Kenai Peninsula Borough

MEMORANDUM

RE: Right-of-way Vacation: Kuchta Street / Kuchta Estates Subdivision Part One, KN 77-33, and Kuchta Estates Subdivision Part Two, KN 77-189, Kenai Recording District, Section 28, Township 7 North, Range 11 West, S.M.

**ITEM 3 - RIGHT OF WAY VACATION
VACATE A PORTION OF KUCHTA STREET AND ADJOINING 5' UTILITY EASEMENT
KUCHTA ESTATES HANSEN ADDITION**

**Proposed Right of Way Vacation
and associated utility easement**

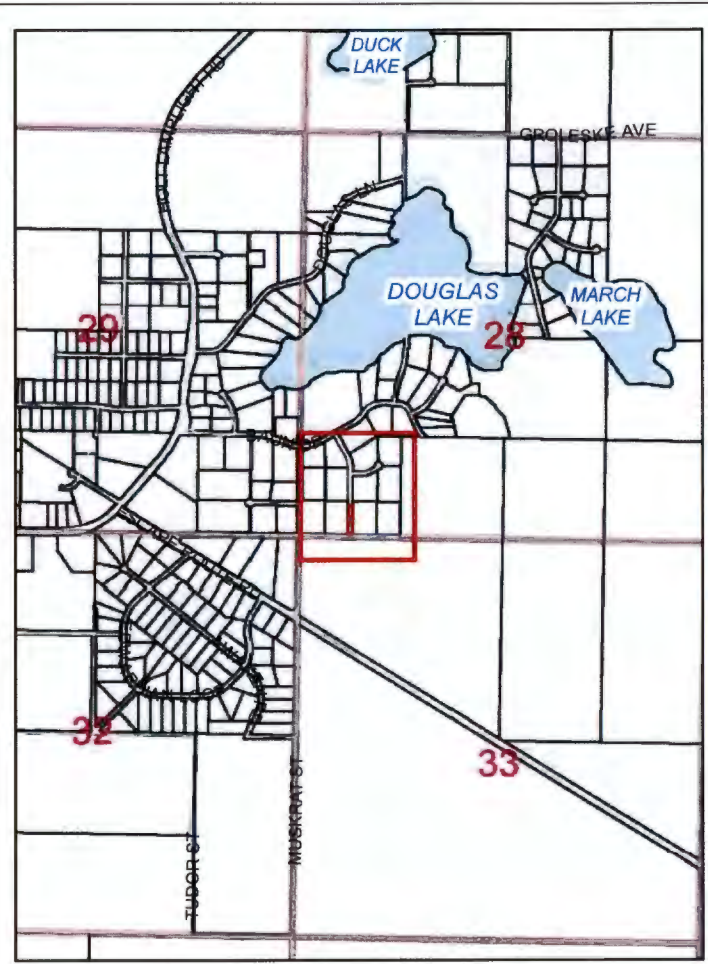
Homer Electric Association did comment that they have an existing distribution line along or within the west portion of Kuchta Street. They are requesting a 20 foot wide easement centered on the existing line.

7. All existing and future utility requirements are met. Rights-of-way which are utilized by a utility, or which logically would be required by a utility, shall not be vacated, unless it can be demonstrated that equal or superior access is or will be available. Where an easement would satisfactorily serve the utility interests, and no other public need for the right-of-way exists, the commission may approve the vacation and require that a utility easement be granted in place of the right-of-way.
Staff comments: A power line is located on the west side of the vacation. Homer Electric Association is requesting an easement over an existing line. The proposed plat will be granting a 20 foot utility easement on the existing overhead line as well as 15 foot utility easements adjoining all right of ways.

1. Consent by KPB Assembly.
2. Compliance with the requirements for preliminary plats per Chapter 20 of the KPB Code.
3. Grant utility easements requested by the utility providers.

ACCESS MAP

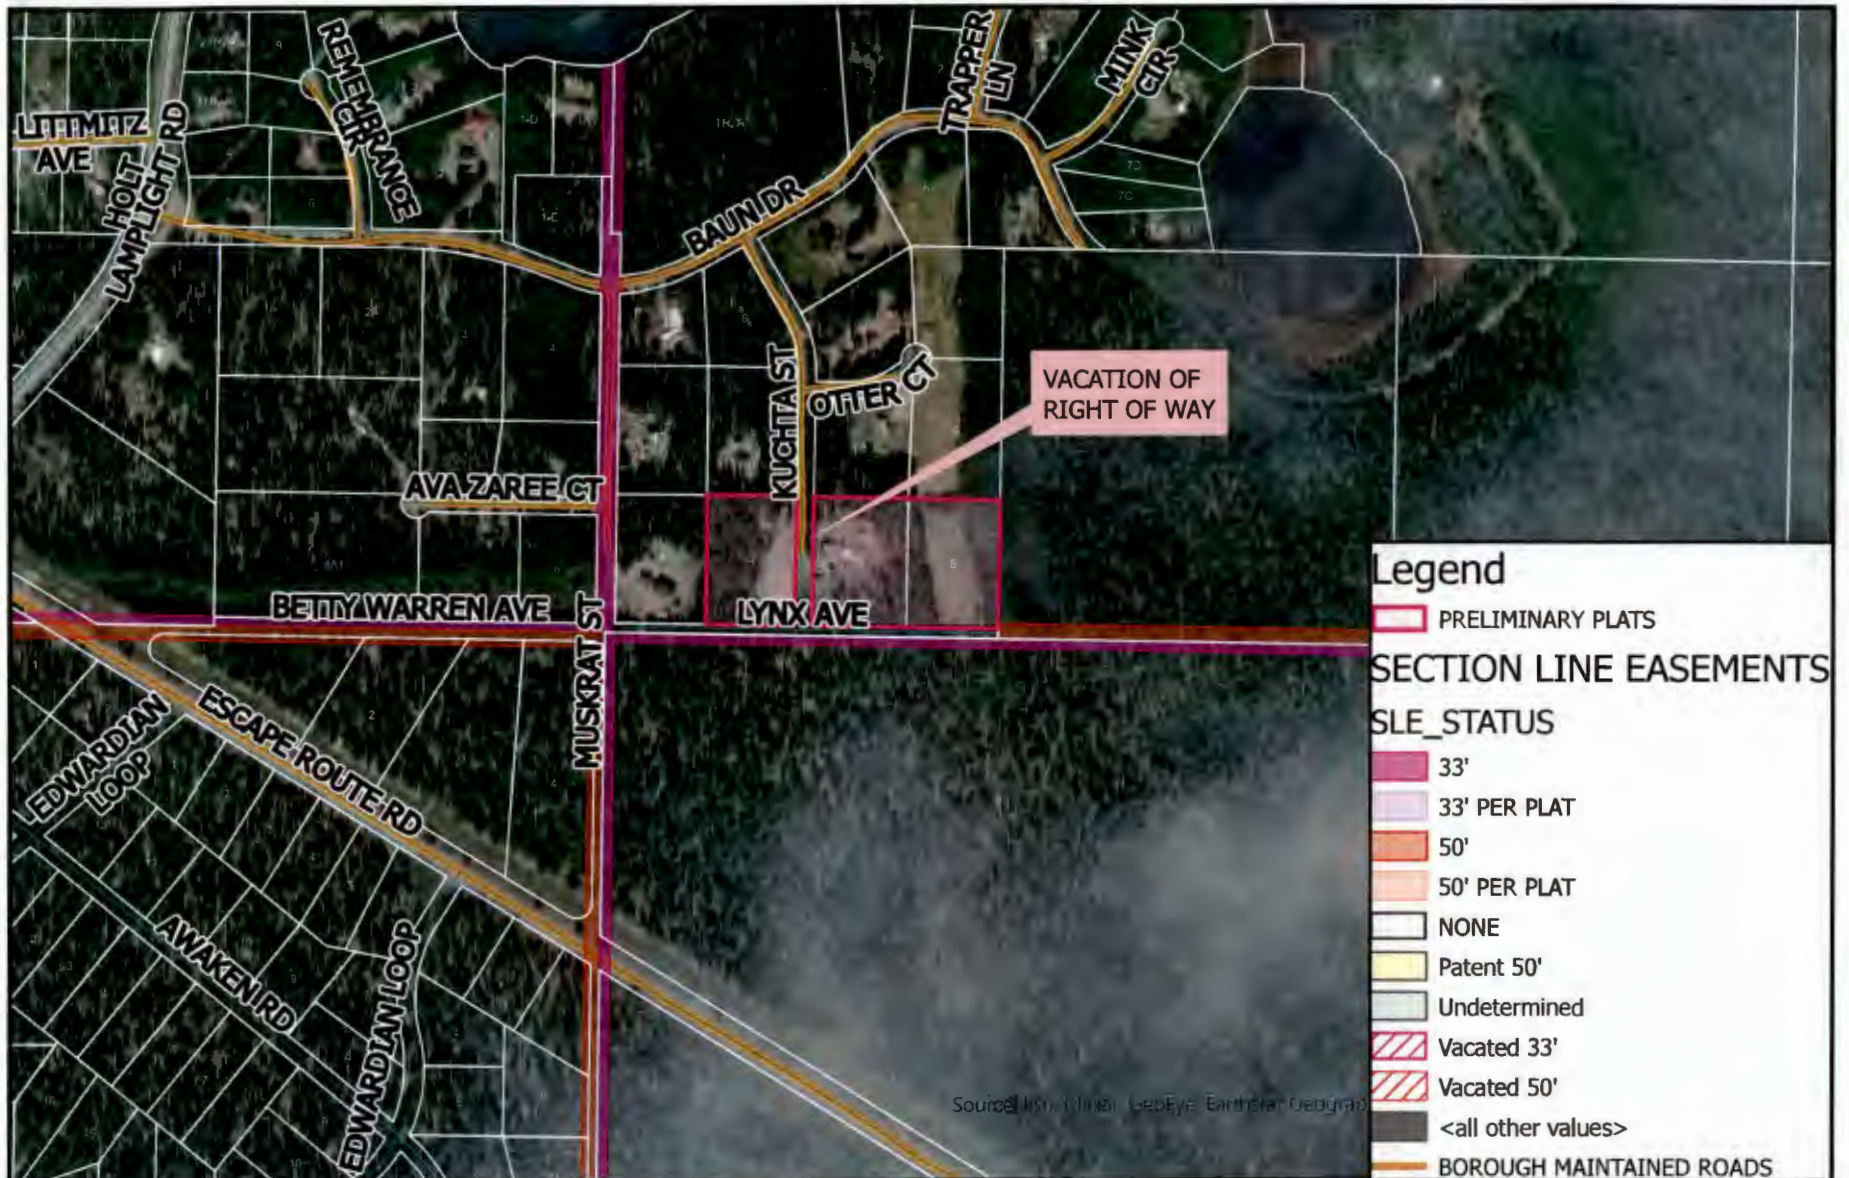
KPB Roads Dept. comments	Within KPB jurisdiction. A portion of this vacate is maintained by the RSA. The current turnaround will be vacated, which will create an issue of maintenance.
SOA DOT comments	No comments.

Per KPB GIS data, Kuchta Street is constructed and a portion is maintained by the borough. The access map prepared by staff indicates the approximate location road maintenance ends. Per KPB GIS imagery, there are structures possibly within the right of way, building setback, or are very close to the right of way.
